Application for Certification (15-AFC-01)

Puente Power Project (P3)
Oxnard, CA

Project Enhancement and Refinement Demolition of Mandalay Generating Station Units 1 and 2

November 2015

FIGURE 2-1

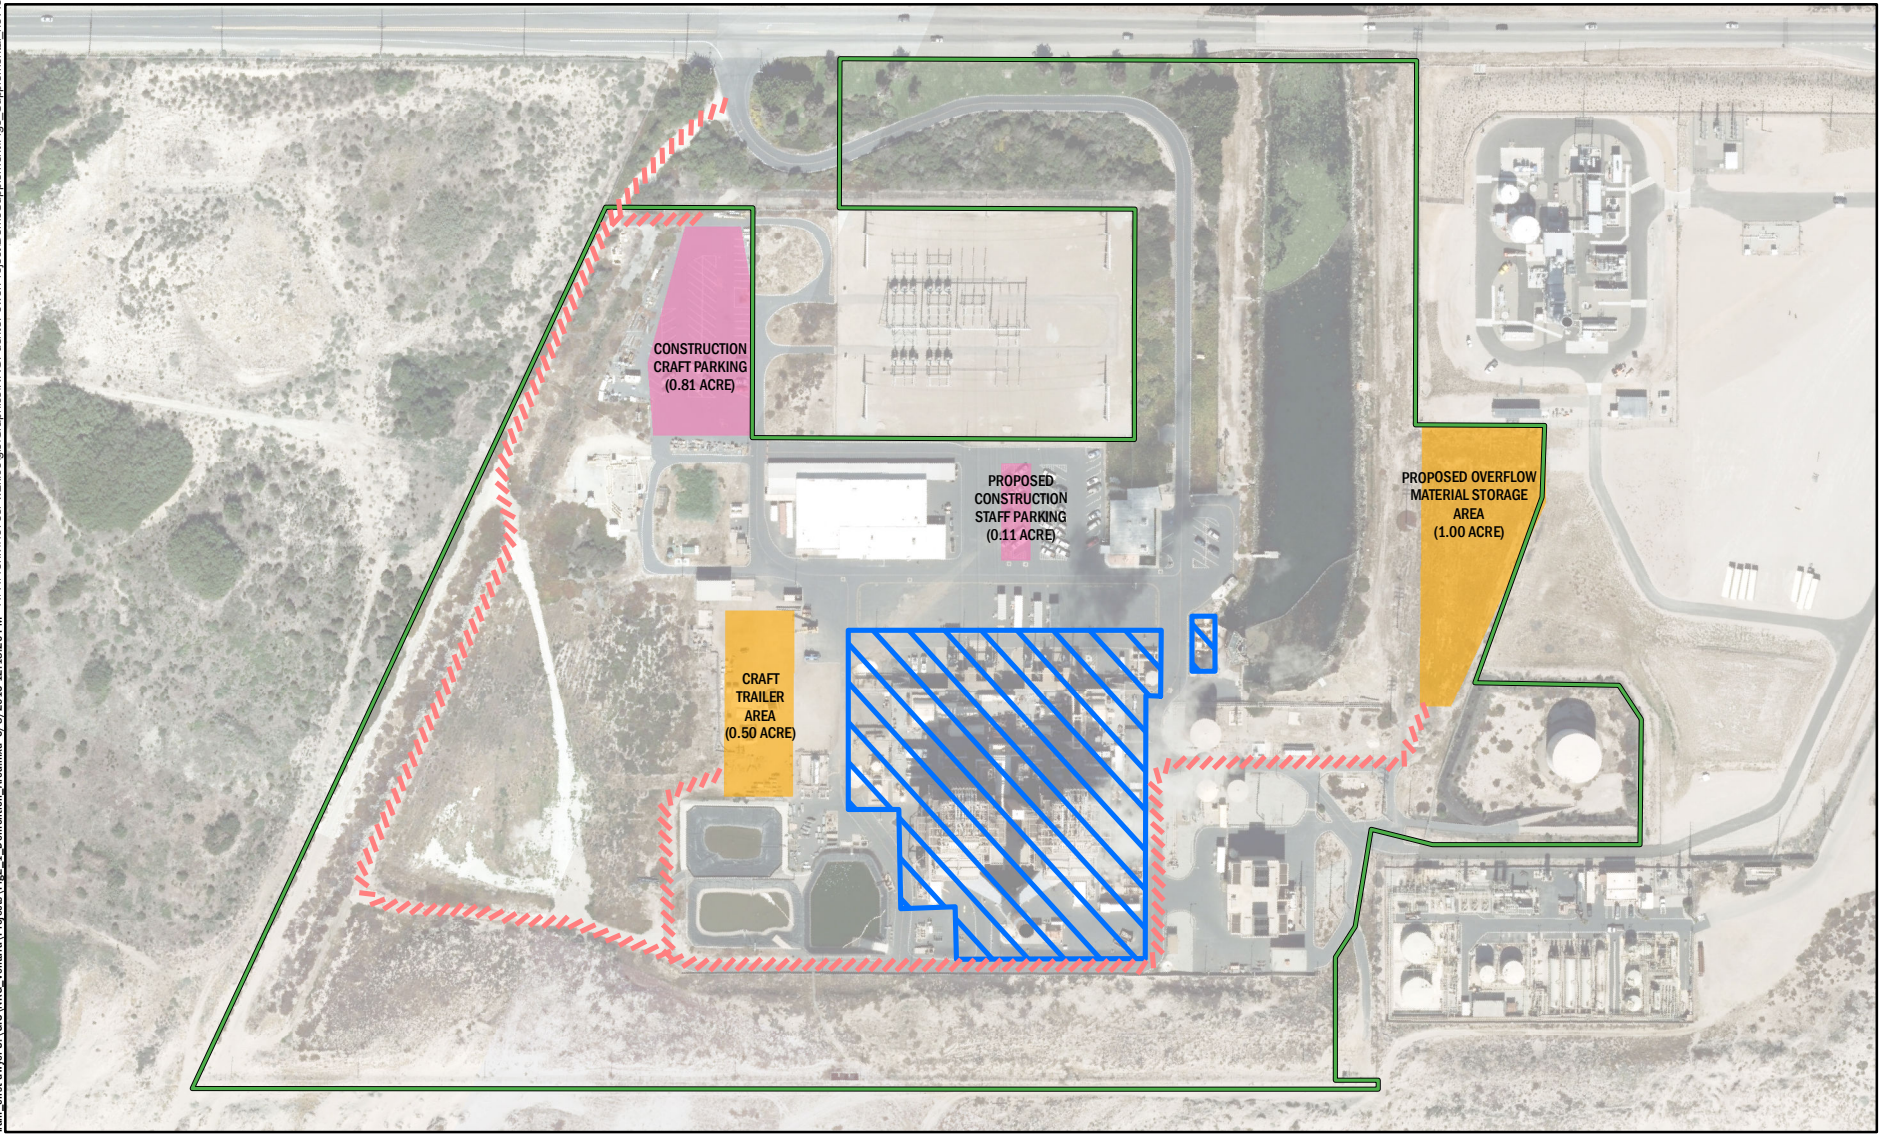
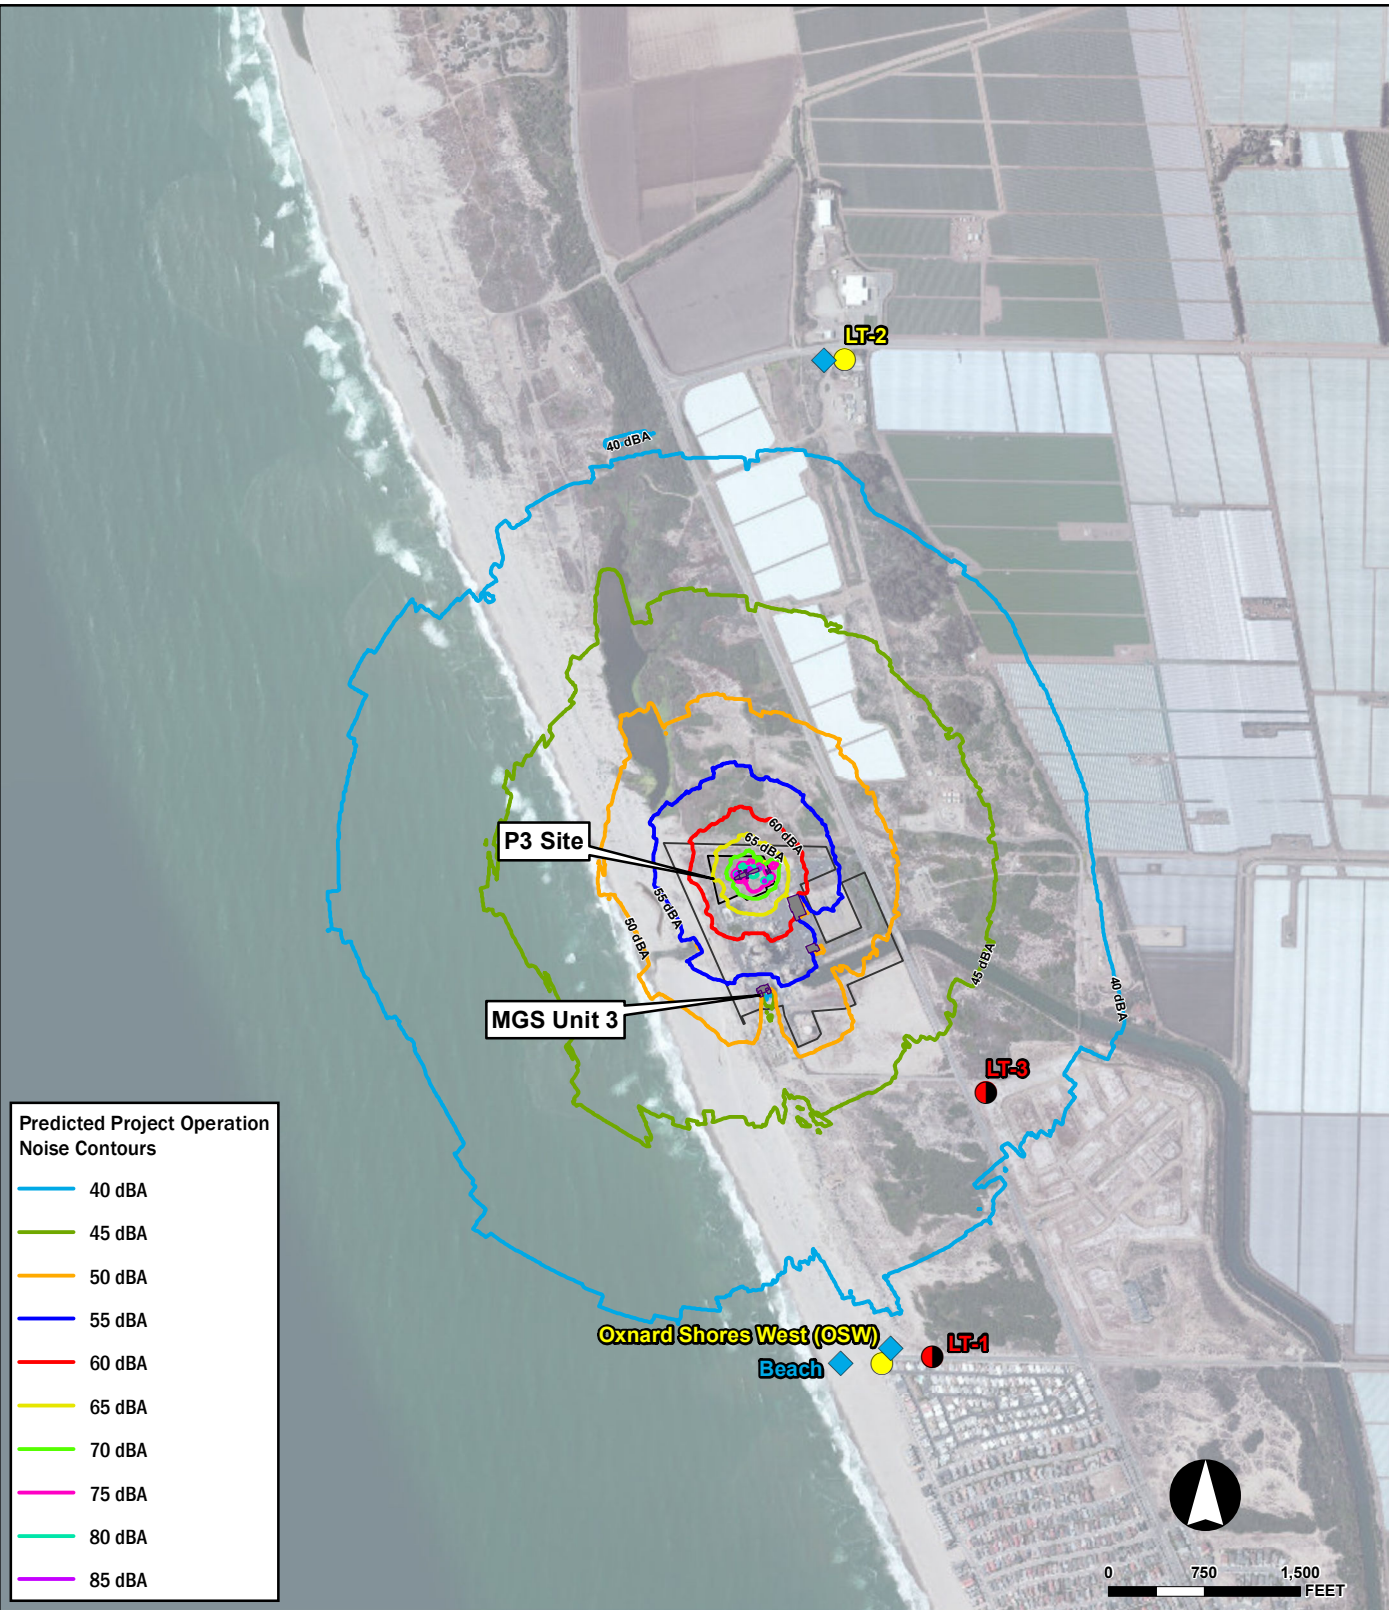
The demolition areas are shown on Figure 2-1. The demolition of Units 1 and 2 will generally occur in the western portion of the MGS property, south of the three basins and north of the water storage tanks area. The demolition area is approximately 3.5 acres. As shown on Figure 2-1, all construction laydown and parking areas will also be within the existing MGS site, and are the same areas that are to be used during construction of P3.

The footprint of the demolition will be approximately 3.5 acres; this consists of the existing MGS Unit 1 and 2 structures and adjacent paved area, as shown on Figure 2-1. During demolition, construction staging areas that were previously used during P3 construction will be available for use during the 15-month demolition period.
